Our Ref: 2017/510813
File No: S112830.009

WestConnex Stage 3 M4-M5 Link Environmental Impact Statement

Please find attached the City of Sydney's (the City) submission on the WestConnex Stage 3 M4-M5 Link Environmental Impact Statement (EIS).

Figure 4. Lower north-south screenline volumes for M4-M5 Link roads

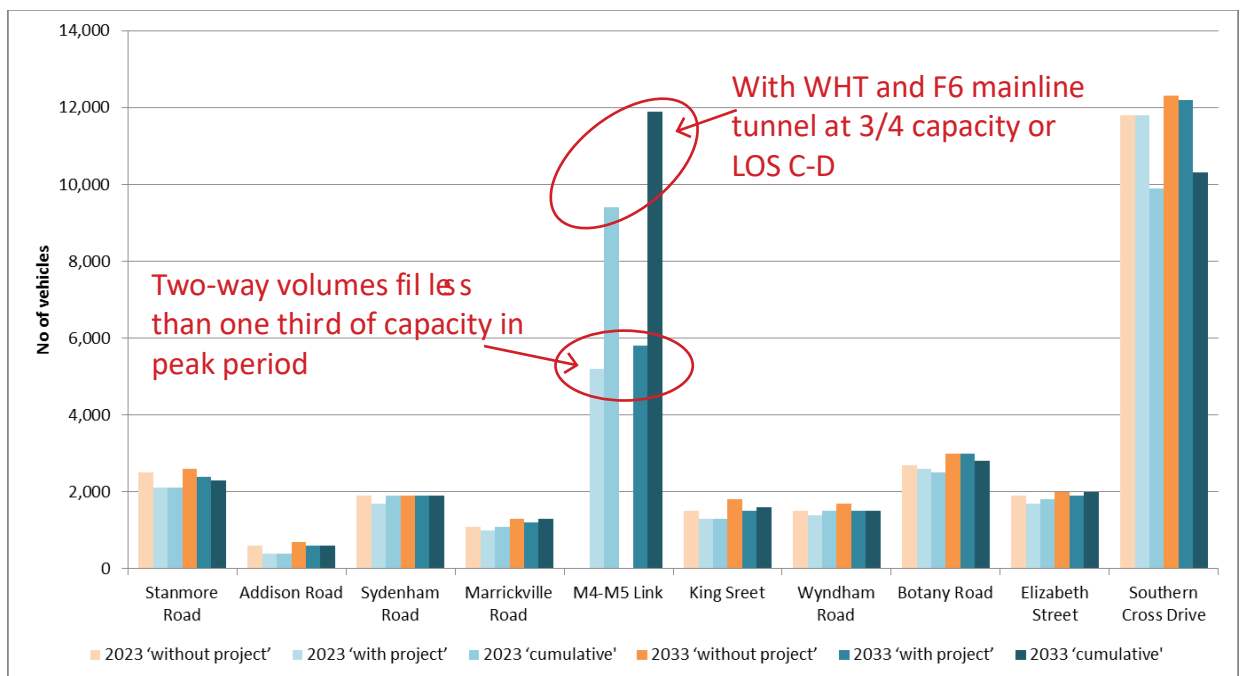
- The EIS provides a few isolated indications of the relationship between projected traffic and capacity on key links affected by the Project.
- Hourly AM peak traffic volume estimates for the mainline tunnel (four lanes in each direction) indicate it would receive traffic volumes that are less than one third of the total capacity available. The hourly capacity for the proposed mainline tunnel of the M4-M5 Link is 16,000 vehicles/hour for both directions at Level of Service E, or 8,000 vehicles/hour in one direction. This is highlighted in Figure 4.

Figure 5. Hourly volumes for roads on Cross-harbour screenline

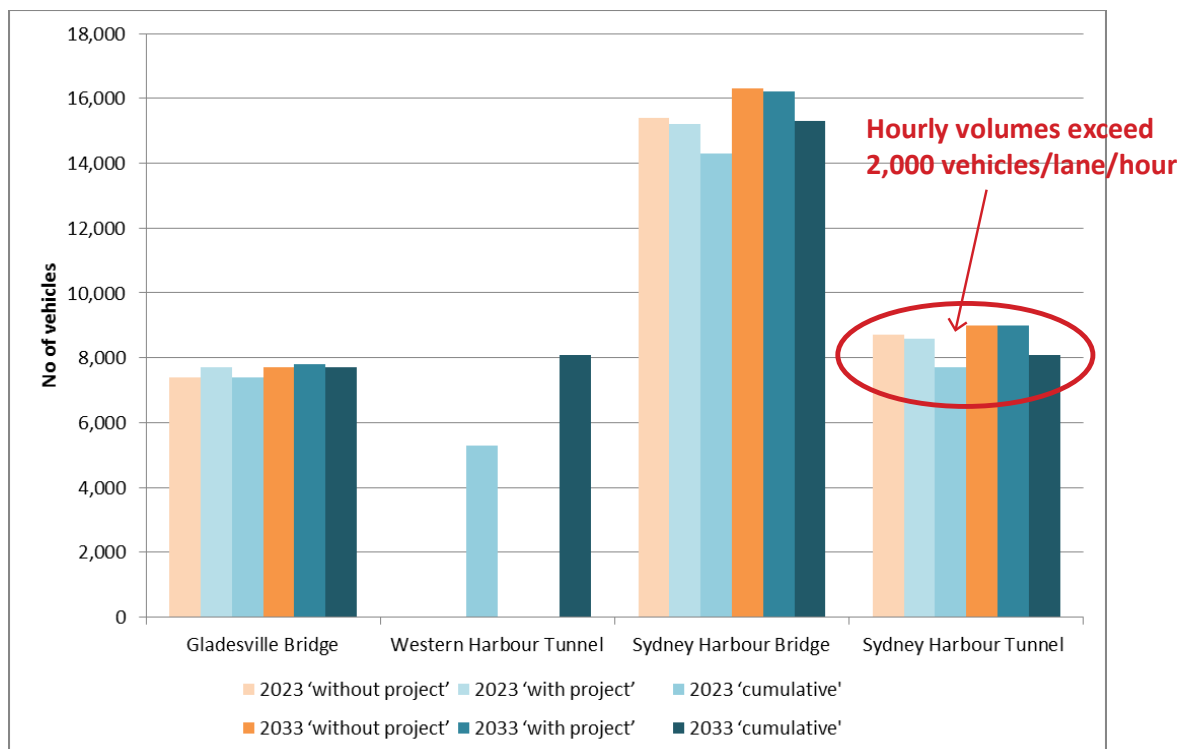
- Figure 5 appears to show that the Western Harbour Tunnel will need to be 4 lanes in each direction and would induce an additional 8,000 vehicles an hour across the harbour, as no other crossing loses that amount of traffic.
- The Sydney Harbour Tunnel has an hourly capacity of some 6,740 vehicles/hour for both directions (see Appendix B). However traffic projections in the EIS show around 9,000 vehicles/hour for both directions in both the 'without project' and 'with project' scenarios. Hourly traffic volumes for the Sydney Harbour Tunnel (two lanes in each direction) would be up to 25 per cent higher than the capacity of the link (highlighted in Figure 5.). This is not physically possible.

Figure 7. Rozelle Interchange operational model boundary + Level Of Service change overlay (AM Peak Hour)

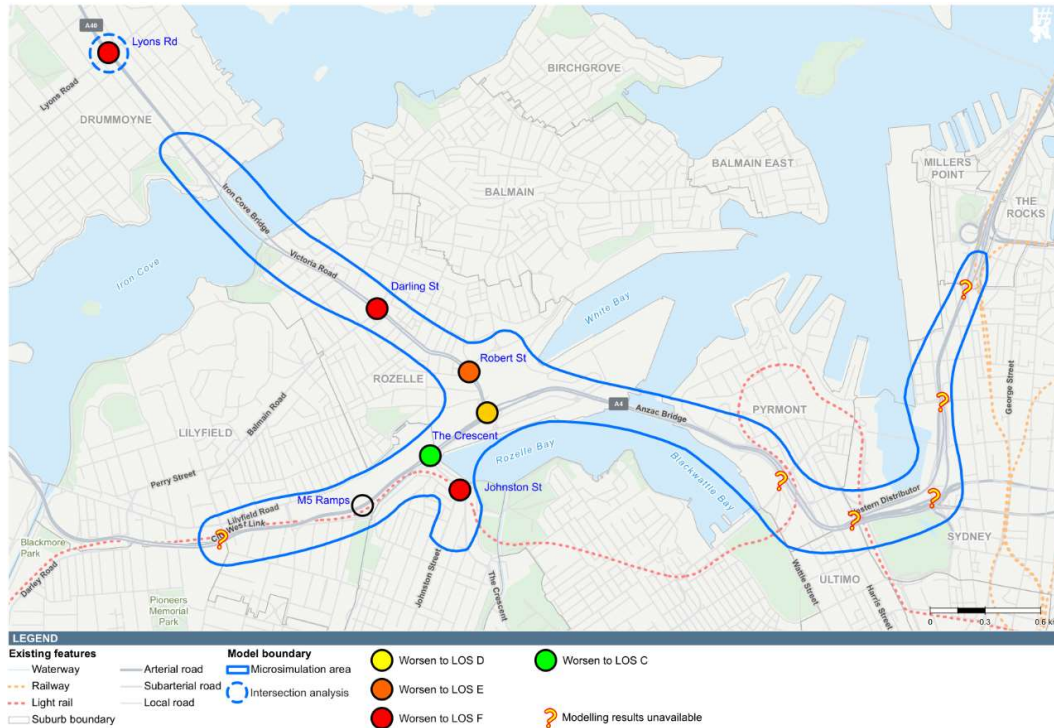
- The Proponent must provide projections of likely queue lengths caused by the Project, especially for the City West Link, Anzac Bridge, Western Distributor and intersections along the western edge of the Sydney city centre.

Figure 8 St Peters Interchange operational model boundary + Level Of Service change overlay (AM Peak Hour)

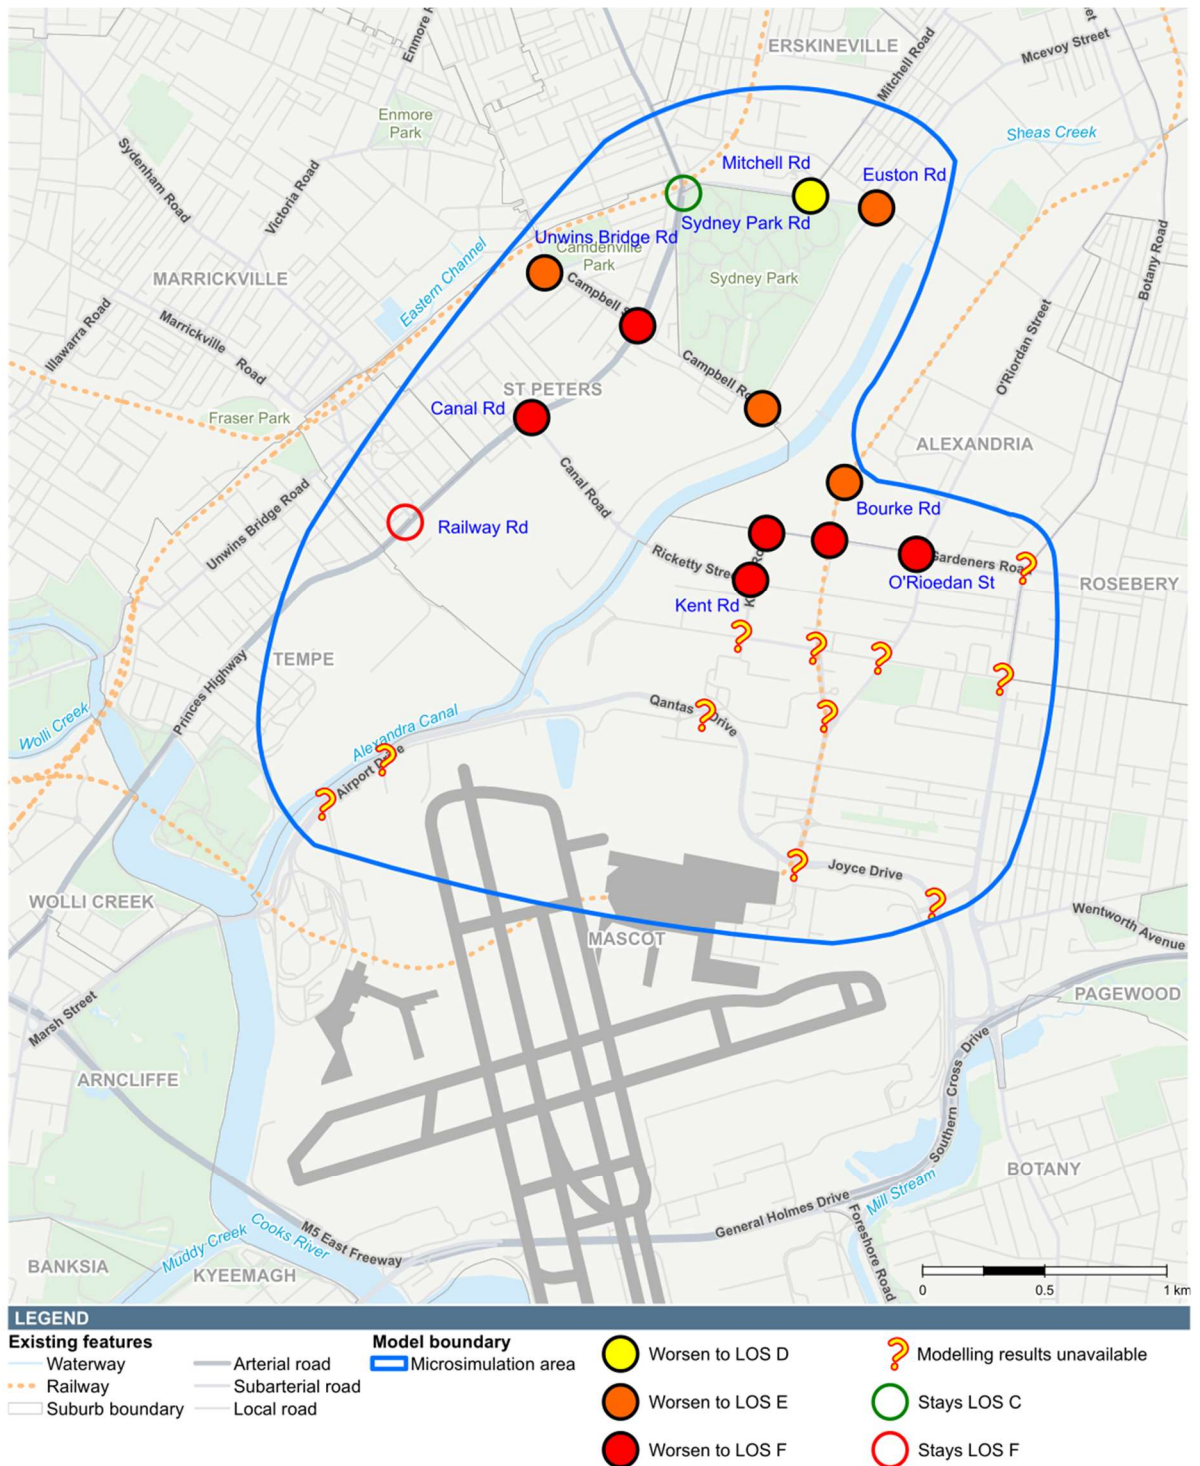
- The Proponent must provide projections of likely changes in traffic volumes on the surface road network in the area around Sydney Airport and Sydney Port

Figure 9 Wattle St Interchange operational model boundary + Level Of Service change overlay (AM Peak Hour)

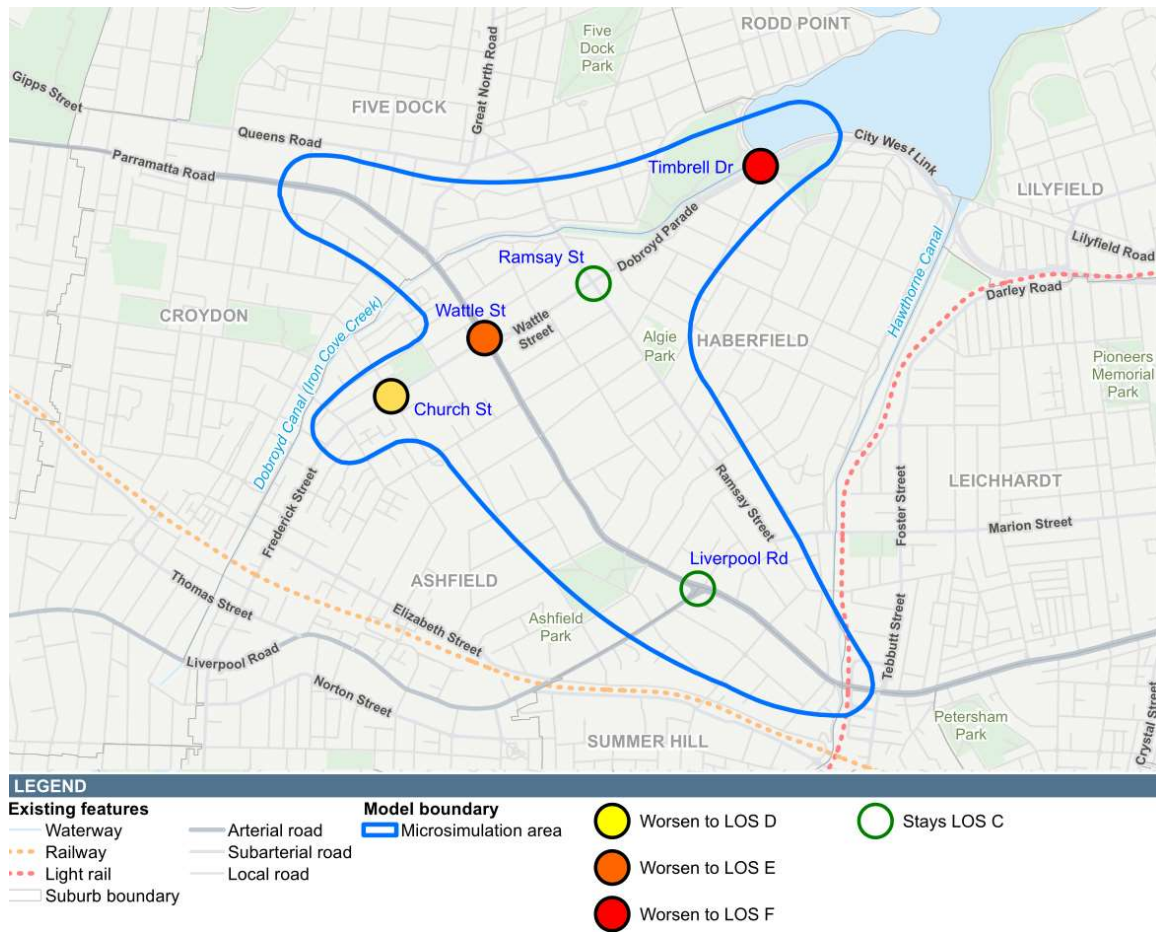
- In the Wattle Street operational model area the EIS indicates that in the AM peak:
 - Most intersections will have a worse Level of Service than the current situation
 - Most intersections will have a worse Level of Service as additional proposed links are added to the network
- The Wattle Street Interchange has exits to:
 - Ashfield, and Georges River Road via Frederick Street
 - Croydon, and Burwood via Parramatta Road
 - Ashfield, Leichardt and Petersham via Parramatta Road

Figure 12 Hourly traffic volume counts over a 24-hour period for the Sydney Harbour Tunnel (counting station 1.003) for 2017

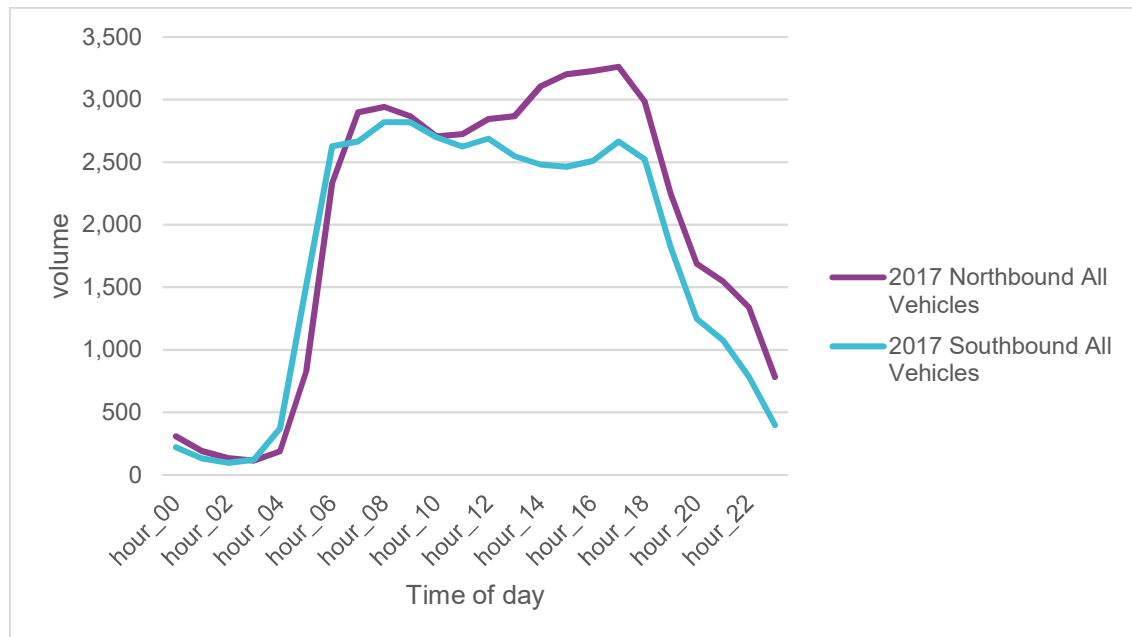
When tested against real data for traffic flow through the Sydney Harbour Tunnel, the practical capacity of 3,370 appears to be in alignment with the real volume counts measured by the RMS (see below)
